[Docket No. 94–CE–28–AD; Amendment 39–9472; AD 95–26–13]

Airworthiness Directives; The New Piper Aircraft, Inc. (Formerly Piper Aircraft Corporation) PA28 and PA32 Series Airplanes

ACTION: Final rule.

Figure 1

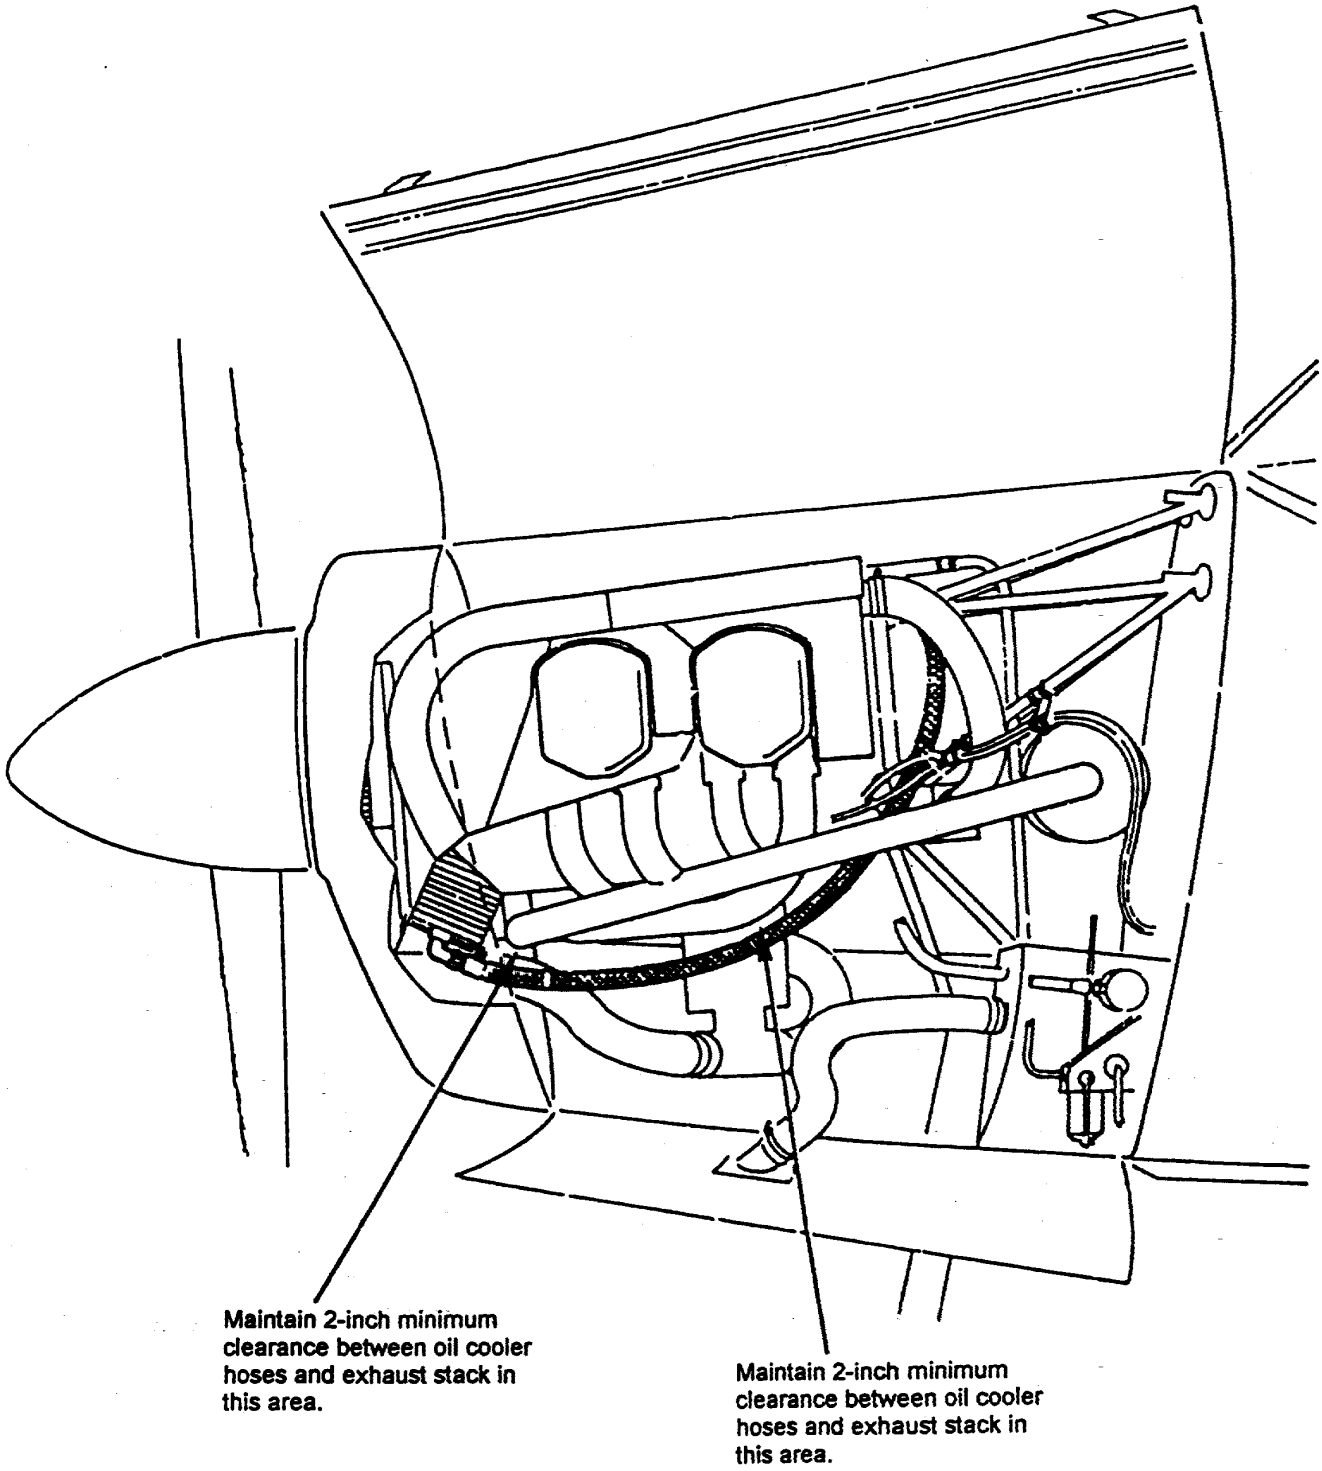
(2) On airplanes that have any oil cooler hose assembly mounted in the front of the airplane, ensure that the following exists, and, prior to further flight, adjust accordingly:

(i) The hose passes underneath and behind the electrical ground cable and in front of the lower of the two engine mount struts when the hose is routed to the rear of the engine; and

(ii) The hose is tied to the engine mount strut and a clearance of at least 2 inches exists between the oil hose and exhaust stack.

Note 2: Figure 1 of this AD relates to the conditions specified in paragraphs (a)(2)(i) and (a)(2)(ii) of this AD.
